Access Compliance Report

Public Rights-of-Way

Intersection ID: 23815	Main Street: CARMEL_RD	Cross Street: MONTIBELLO_DR	Location: SW
ADA ID: DD1CE5593DAE	Ramp Type: PerpDiag	Initial Pass/Fail: Fail	Overall Compliance: No
			Severity Score: 21.25

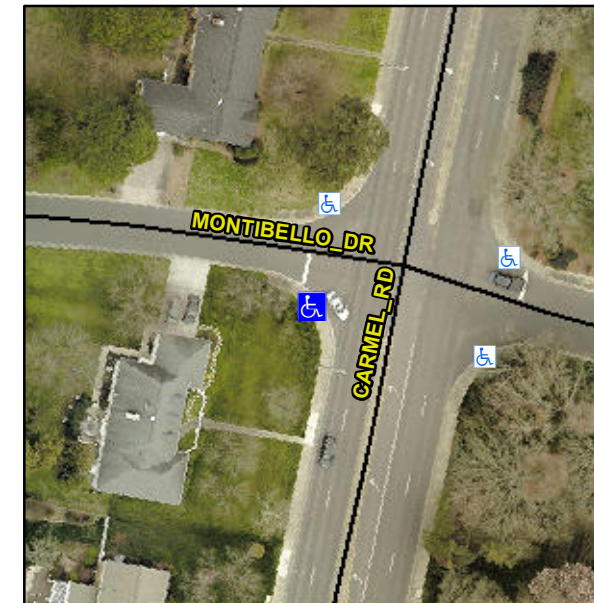
Not Found, R304.5.1, R304.2.2

Compliance	Description	Data	Compliance	Description	Data
N/A	Ramp Length (in)	60.0	No	Ramp Slope (%)	8.9
No	Ramp Width (in)	39.0	Yes	Ramp XSlope (%)	0.9
N/A	Flare Type LT	N/A	N/A	Flare Type RT	N/A
N/A	Flare Slope LT (%)	N/A	N/A	Flare Slope RT (%)	N/A
N/A	Flare Traversable LT?	N/A	N/A	Flare Traversable RT?	N/A
N/A	Landing Length (in)	N/A	N/A	DWS Provided?	N/A
N/A	Landing Width (in)	N/A	N/A	DWS Contrast?	N/A
N/A	Landing Slope (%)	N/A	N/A	DWS Length (in)	N/A
N/A	Landing X Slope (%)	N/A	N/A	DWS Full Width?	N/A
N/A	Landing Curb? (Y/N)	N/A	N/A	DWS Offset (in)	N/A
N/A	Shared Landing?	N/A			
N/A	Gutter Ponding?	N/A	N/A	Gutter Slope (%)	N/A
N/A	Gutter Lip Ht (in)	N/A	N/A	Gutter X Slope (%)	N/A
N/A	Painted X Walk1?	No	N/A	Painted X Walk2?	No
	X Walk 1 Direction	To SE		X Walk 2 Direction	To NE
N/A	X Walk 1 Width (in)	N/A	N/A	X Walk 2 Width (in)	N/A
	X Walk 1 Slope (%)	3.3		X Walk 2 Slope (%)	0.8
	X Walk 1 X Slope (%)	4.8		X Walk 2 X Slope (%)	3.1

Remove & Replace Curb Ramp With Two New Directional Ramps or Equivalent.
